Addendum # 1
Bid Opportunity: 24-7512-RFT - Courtland Public
School HVAC Upgrades
Closing Date: Tuesday, April 2, 2024 2:00 PM

PROJECT NAME
COURTLAND PUBLIC SCHOOL HVAC UPGRADE
 107 COURTLAND AVE. E., KITCHENER, ON. N2G 2T9

**FIRST FLOOR
 RENOVATION PLAN**

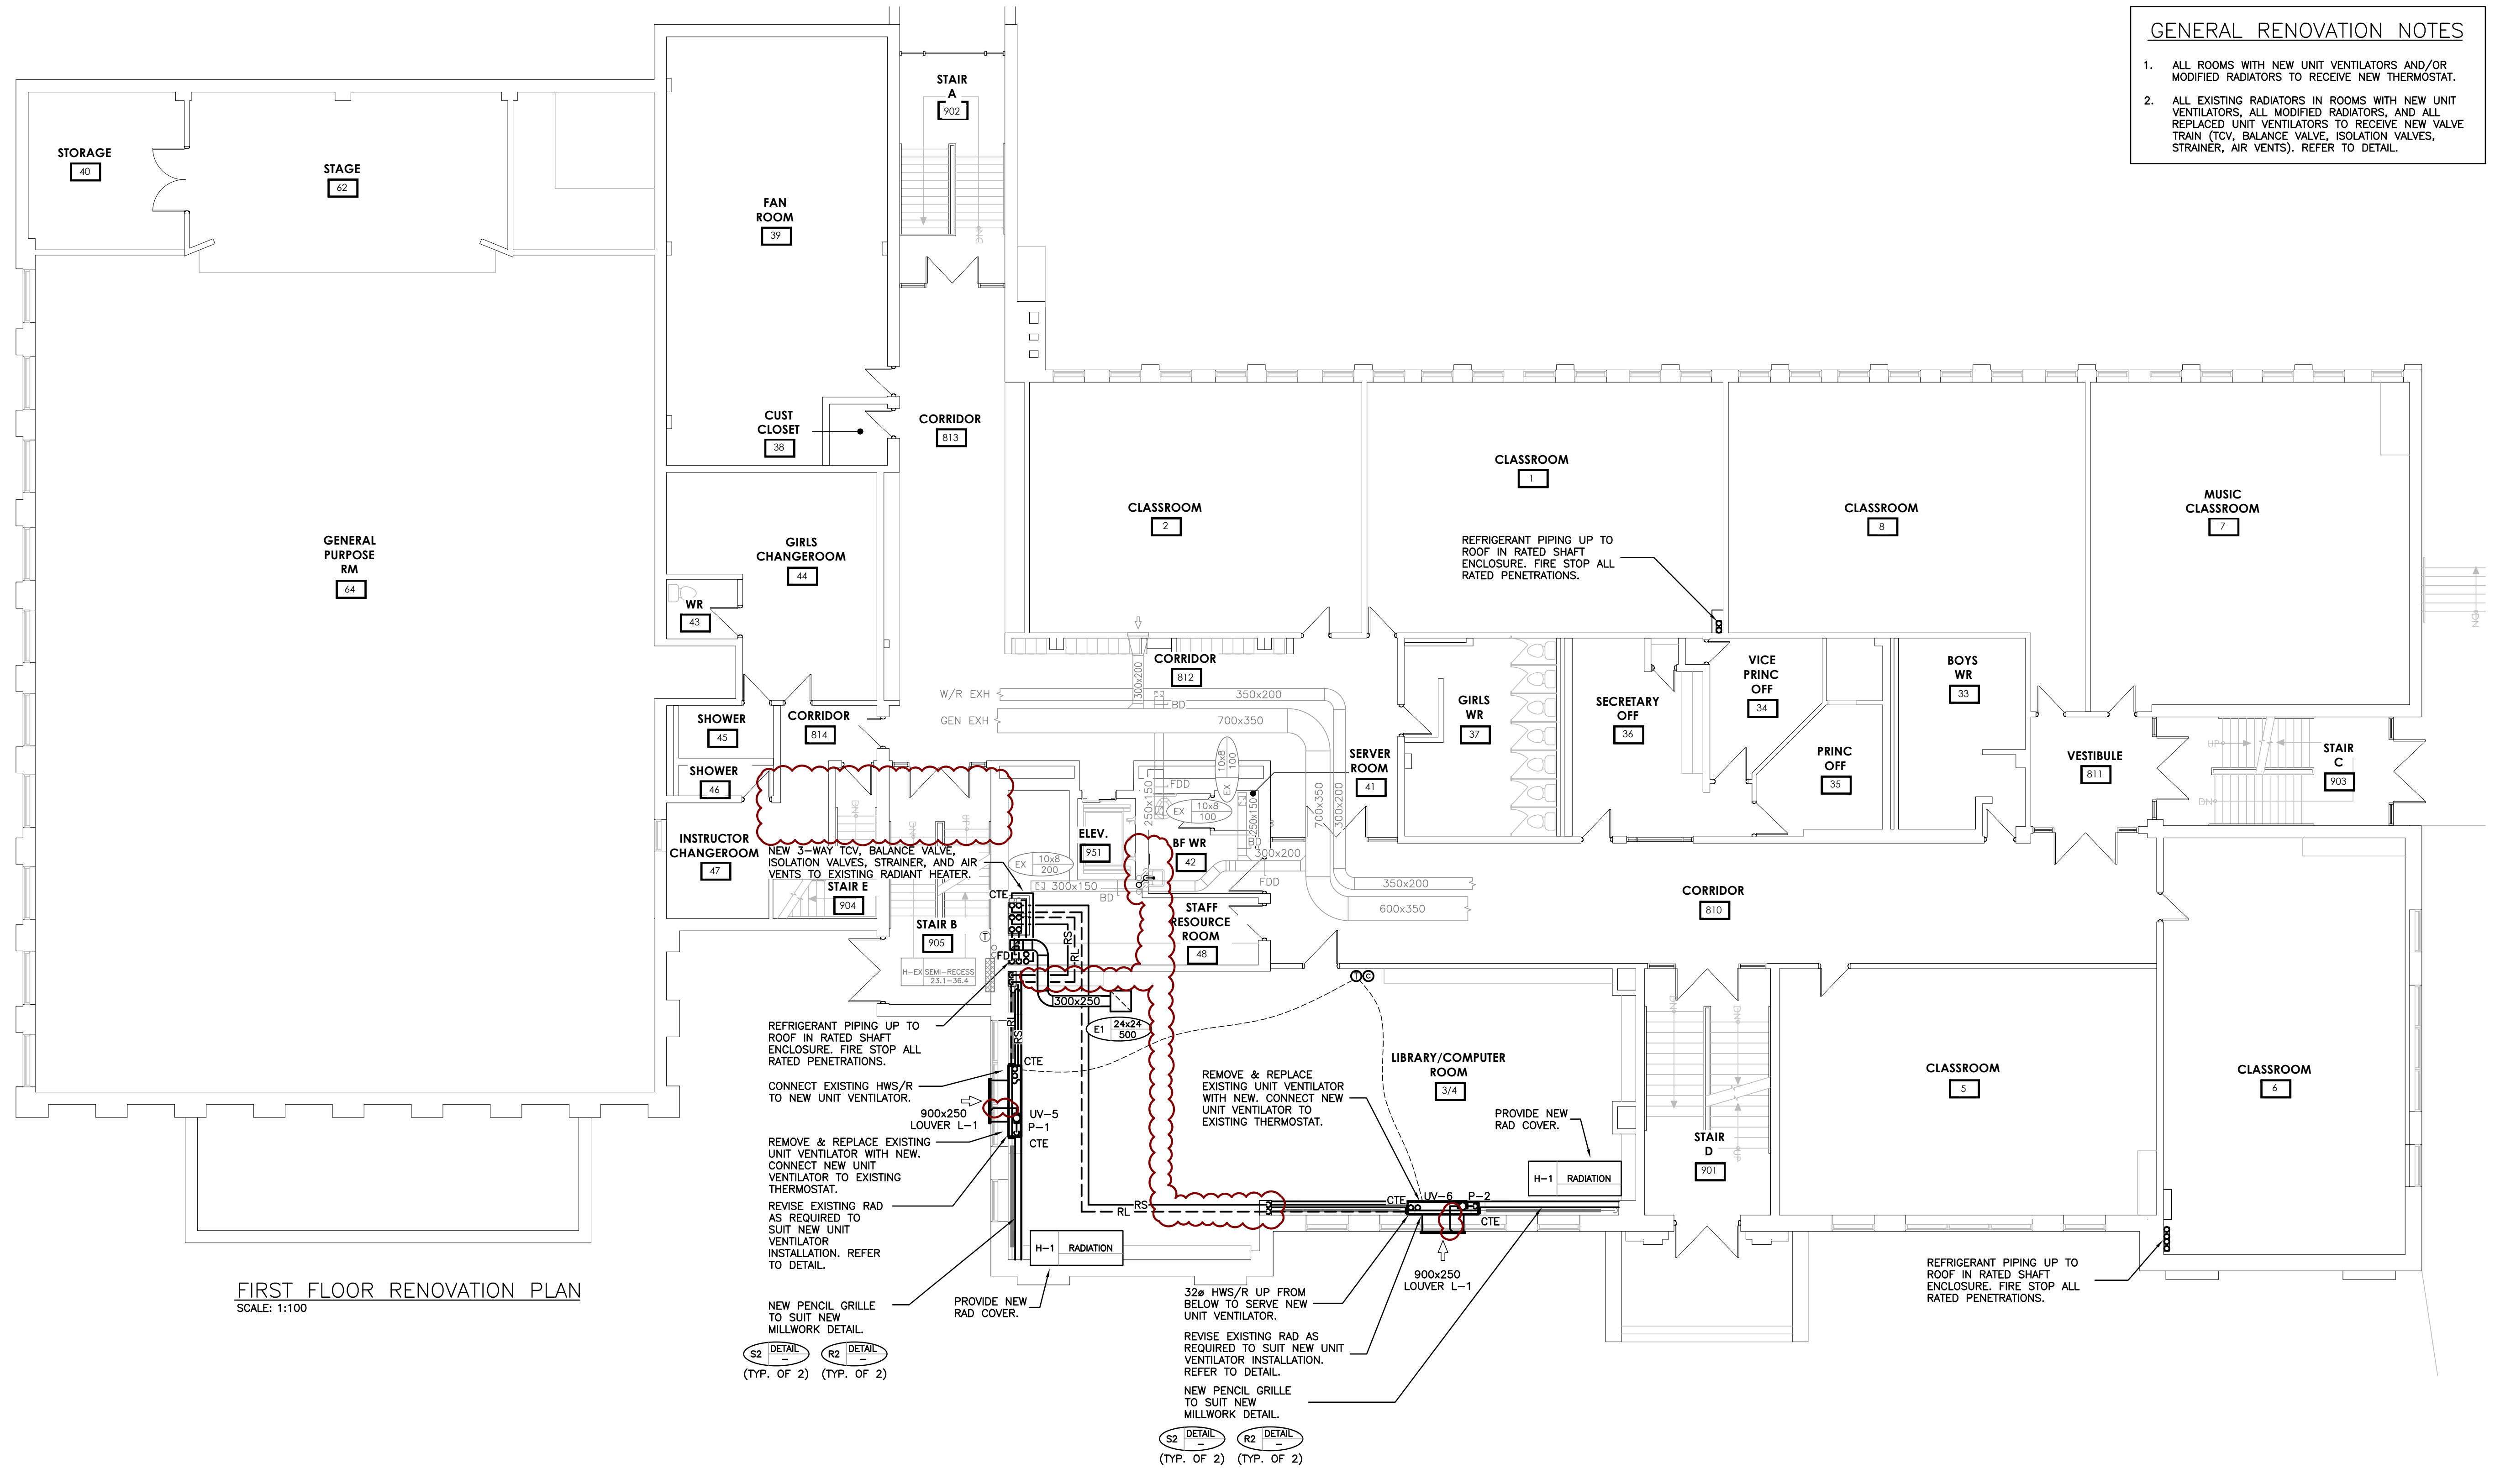
- 2.0 Reference Attached Reissued Drawings M2.2 and M3.3
- .1 Remove Note 13 from drawing M2.2. No demo work required in BF Washroom 42.
 - .2 No new work required in BF Washroom 42.
 - .3 Condensate for UV-5 and UV-6 to discharge through exterior wall.

DRAWING TITLE
**ROOF RENOVATION
 PLAN**

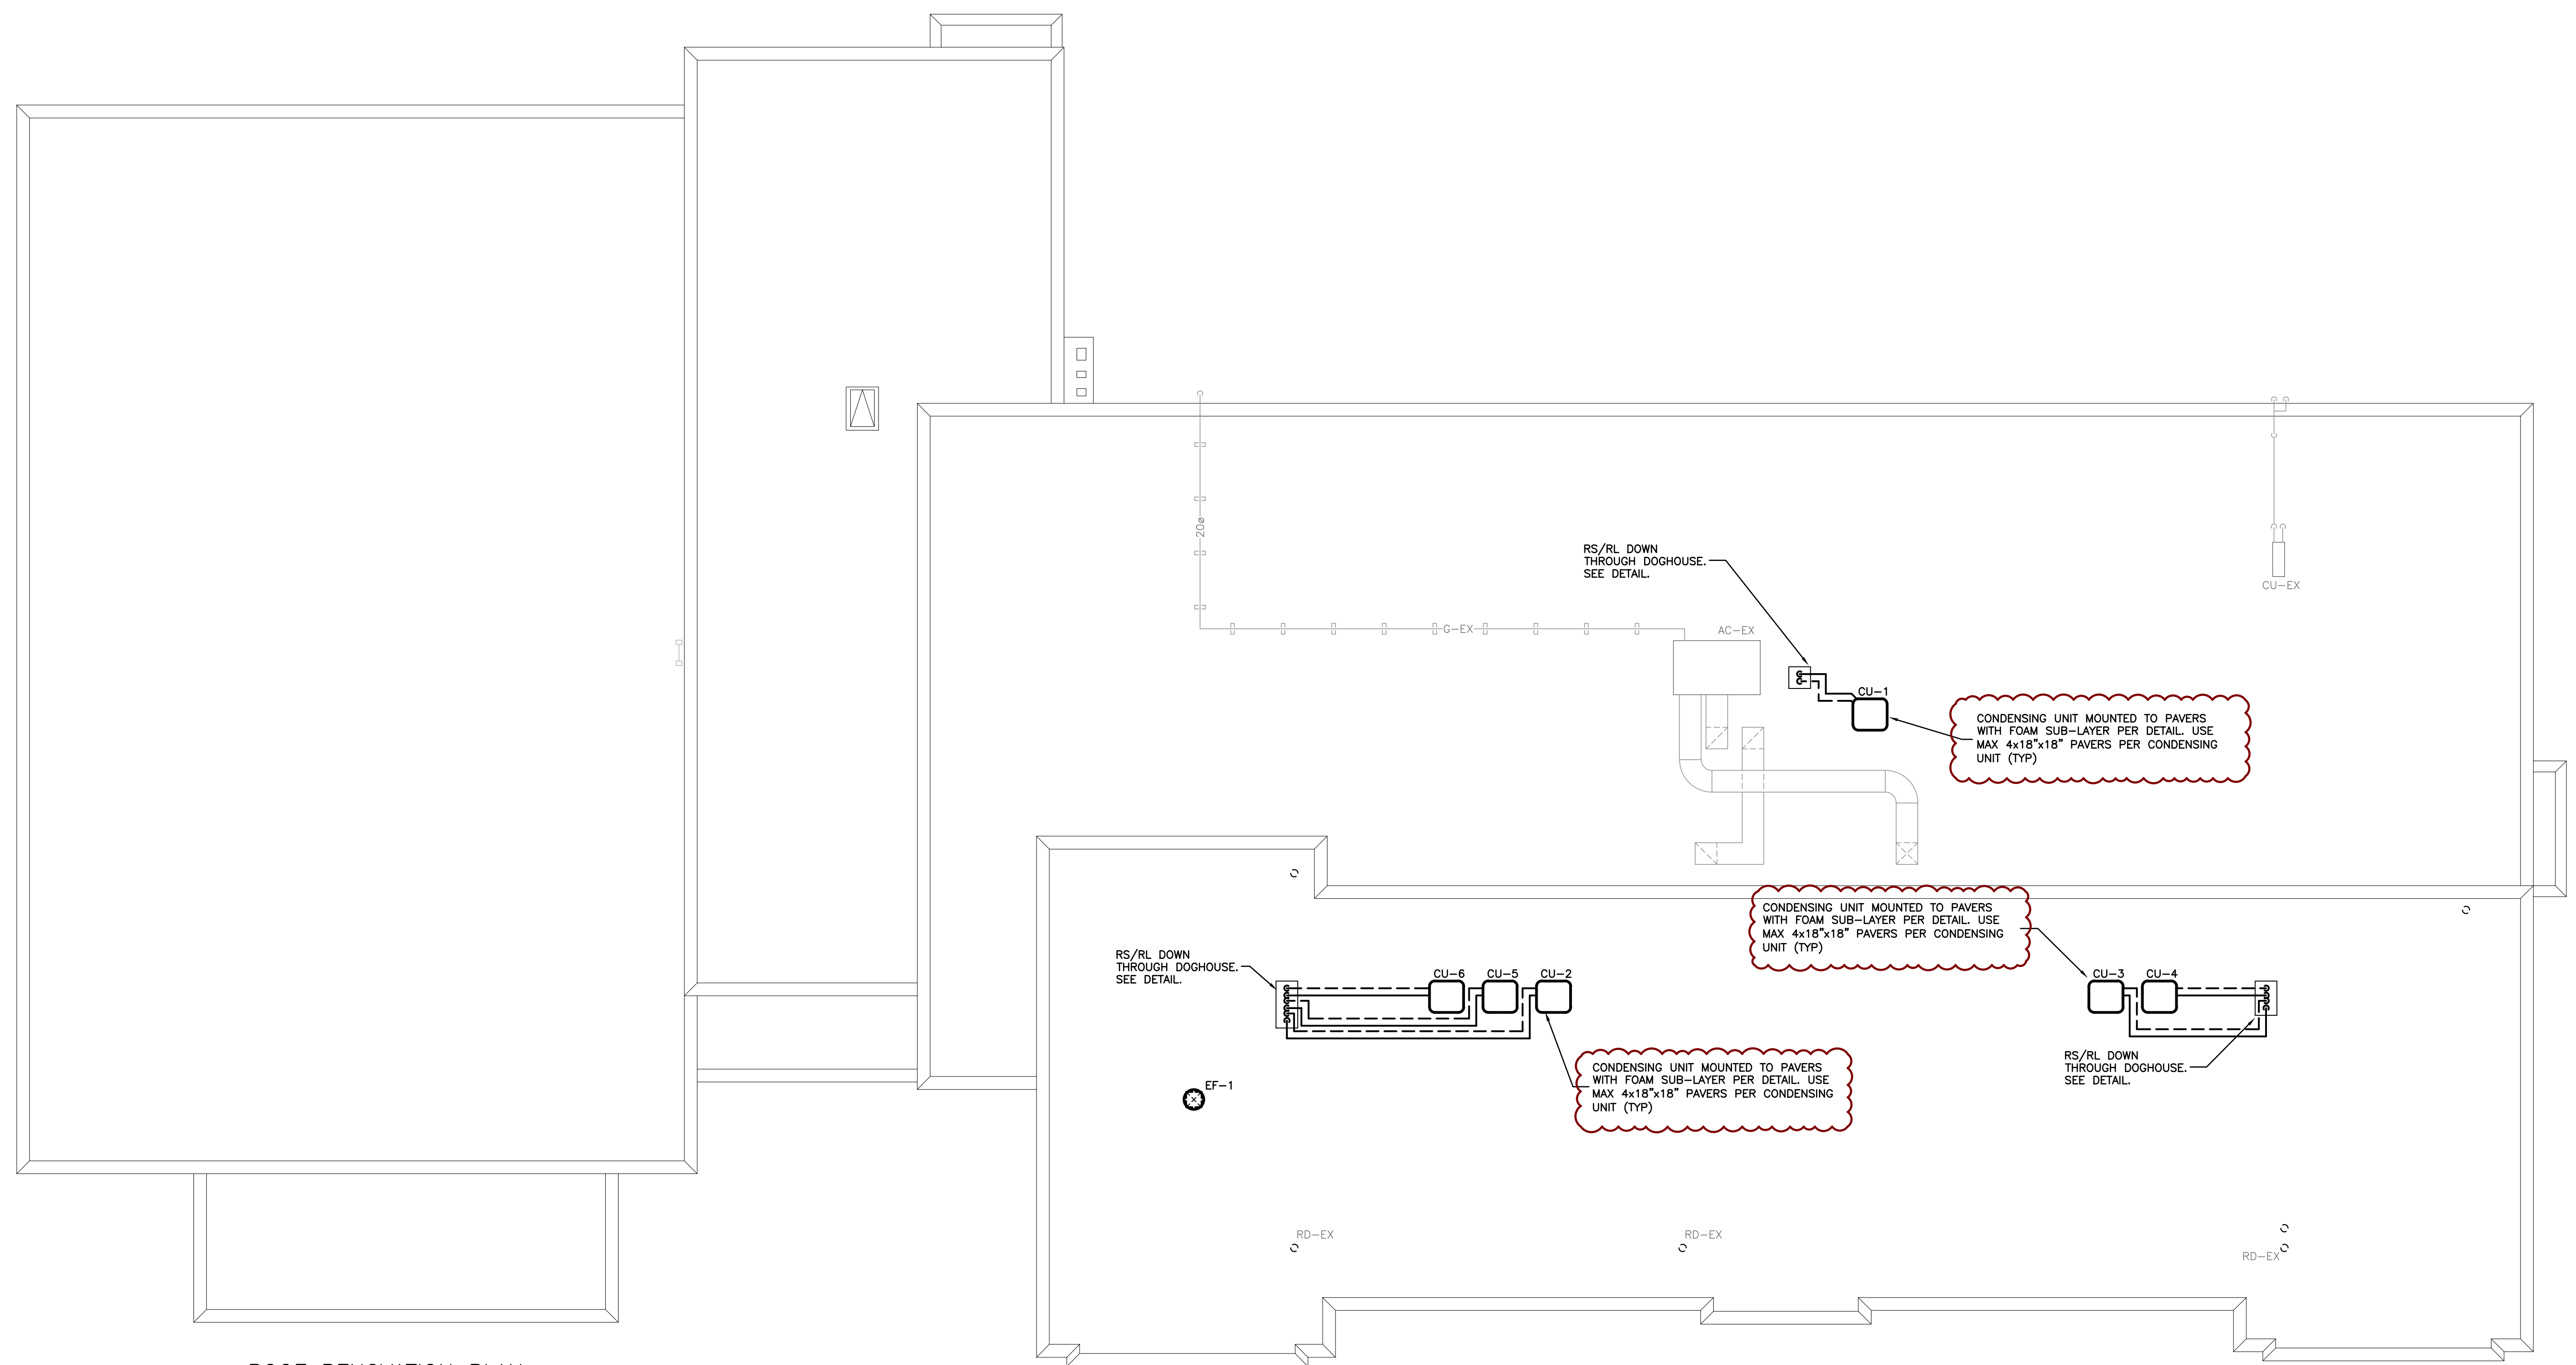
- 3.0 Reference Attached Reissued Drawings M3.5 and M4.1
- .1 Condensing units to be installed on pavers on high-density styrofoam bases. Elevated snow stands are not to be used.
 - .2 Side connection required to radial slot diffusers D2. Detail provided.
 - .3 Provide system drains at all hydronic system low points. Details updated.
